Three lines of thought about Lower Shaker Lake dam

- 1) Downsizing the NEORSD design would meet local needs
- 2) Understanding the dam failure hazards and working towards a non-Class-I project**
- 3) The lake and the 15 minute city

Ben Monreal
Shaker Heights
Professor of Physics, CWRU

Doan Canyon flood capacity is relevant

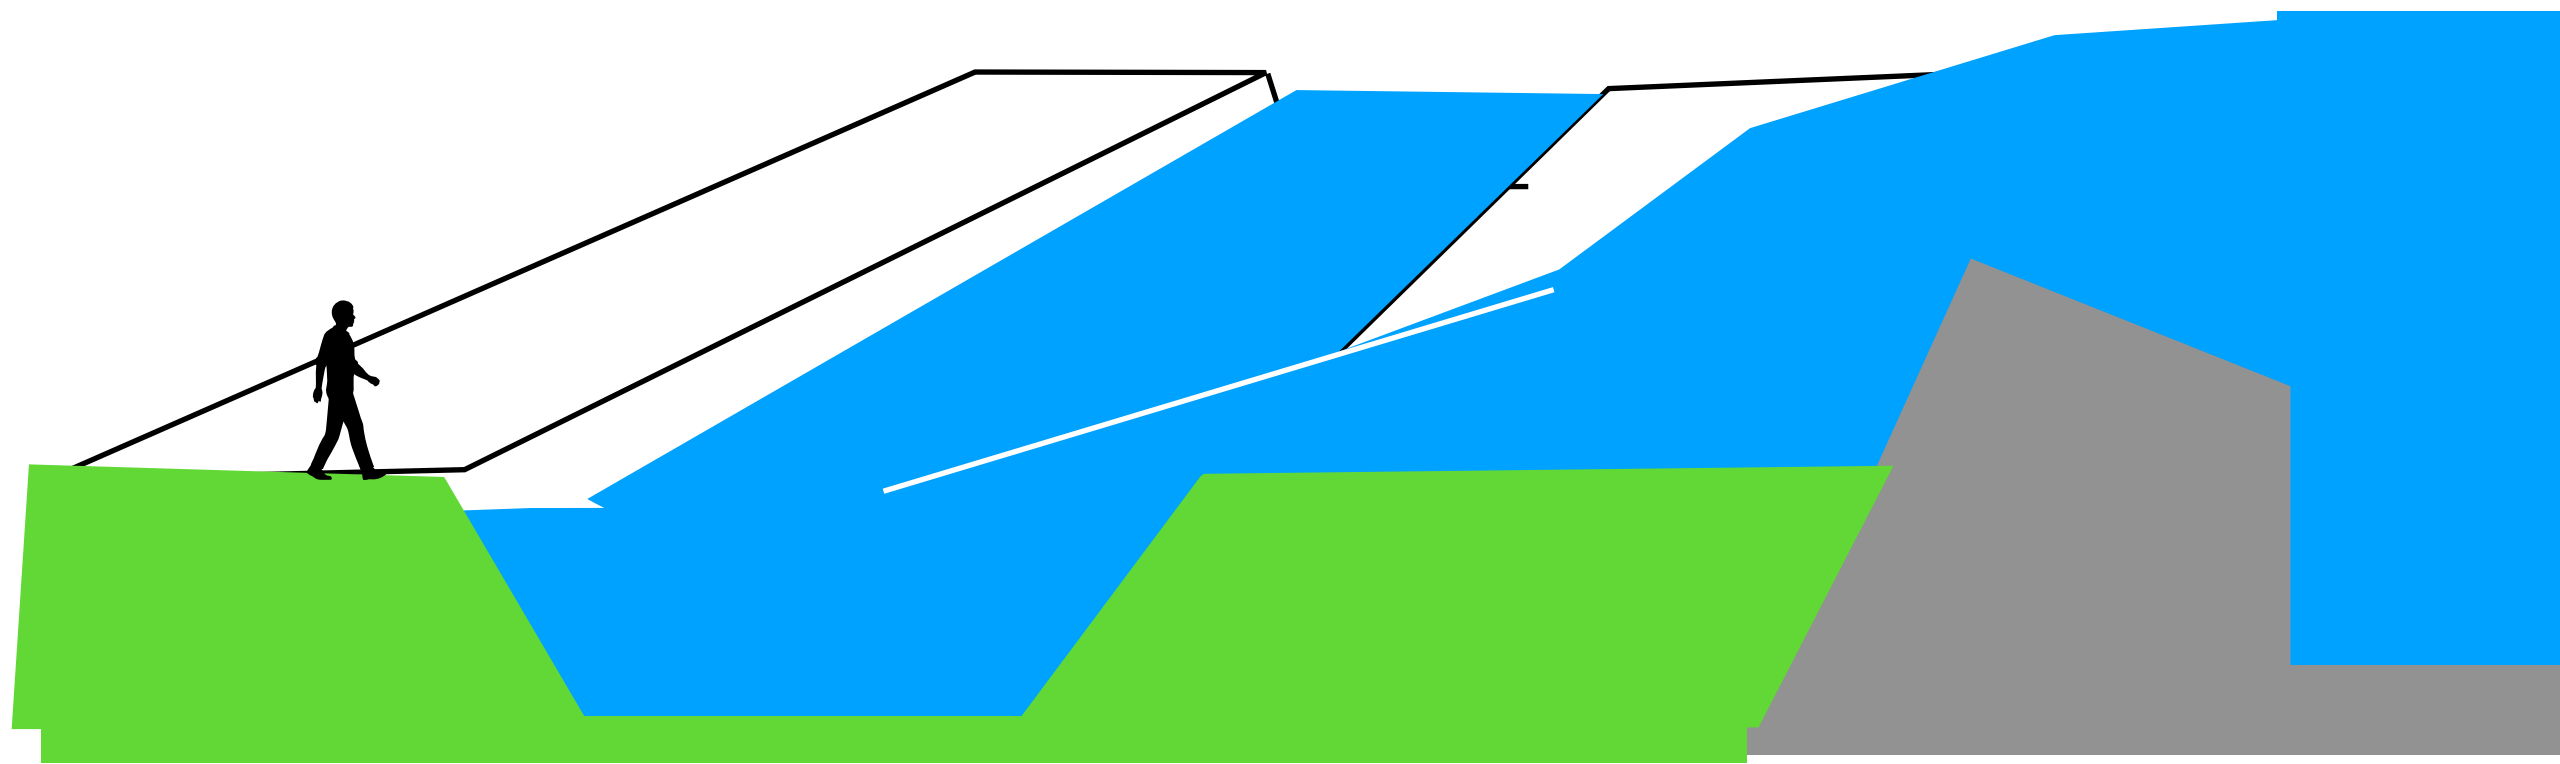
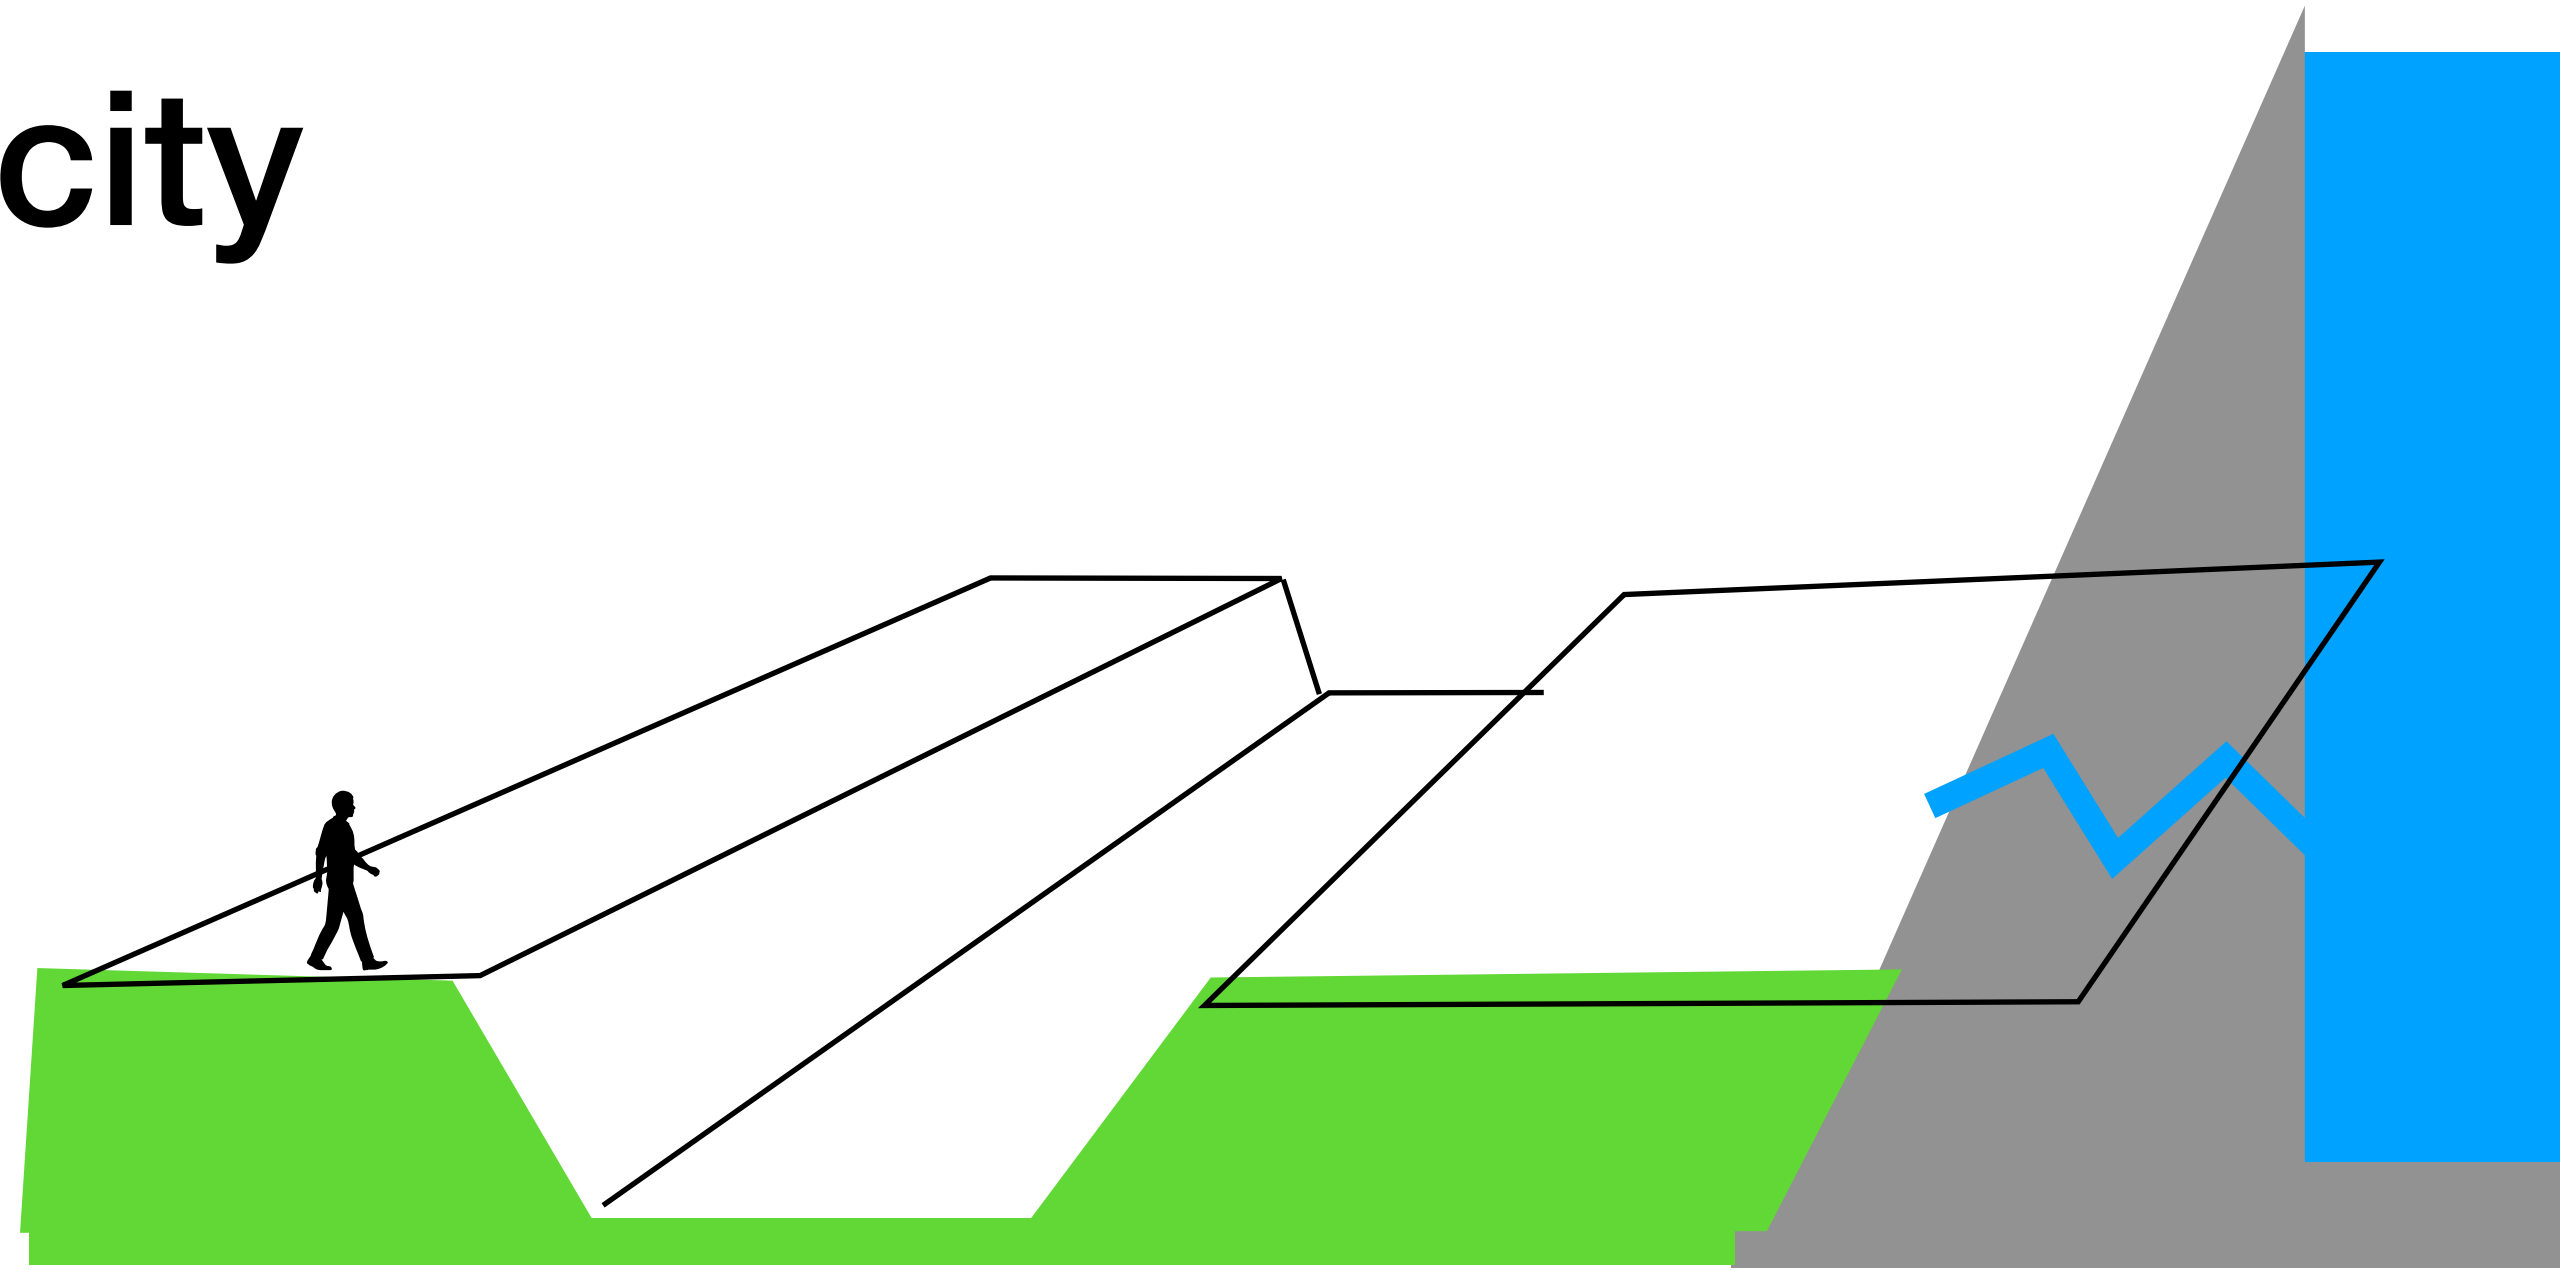
- Dumping a lot of water into a big channel = just looks like a rainstorm = not a hazard
